REMARKS

Serial No.: 09/172,298

Docket No.: M4065.0101/P101

Dated: August 18, 2000

FIG. 1
PRIOR ART

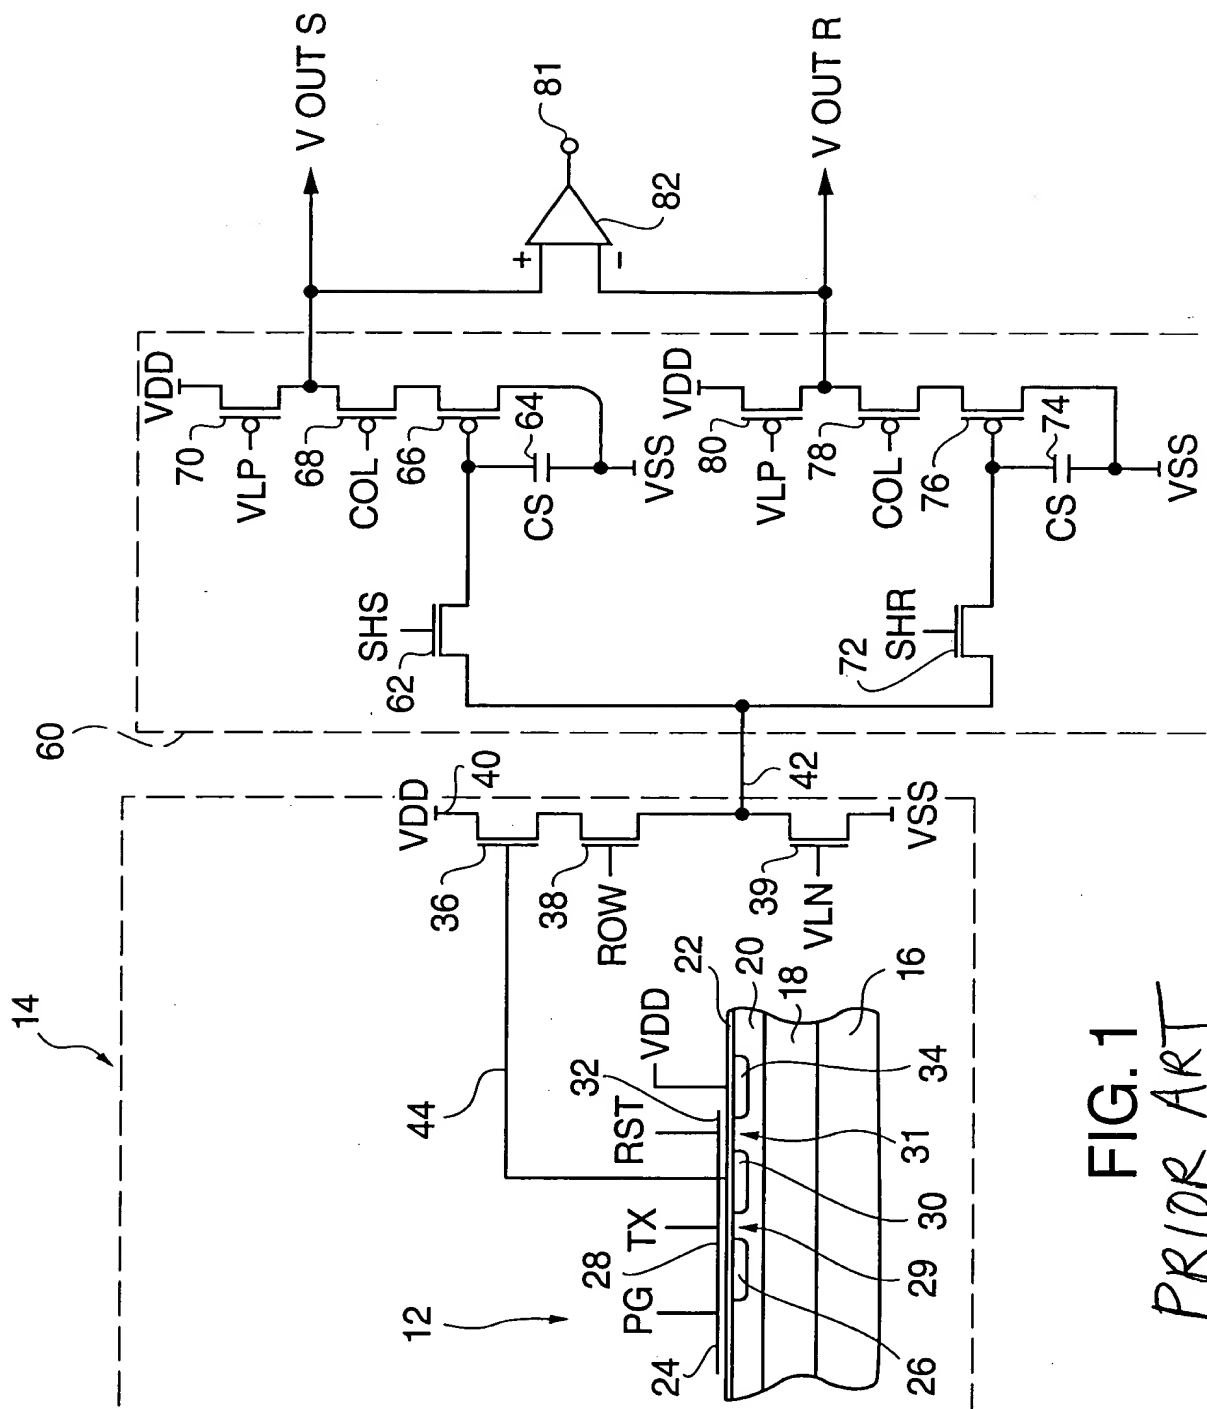
In response to the Patent and Trademark Office's request, applicant has included revised Figures 1, 2 and 3 with the legend "PRIOR ART" indicated in red. The Office's approval of these revisions is respectfully requested.

ok to enter
29/1/99
28 august 2000
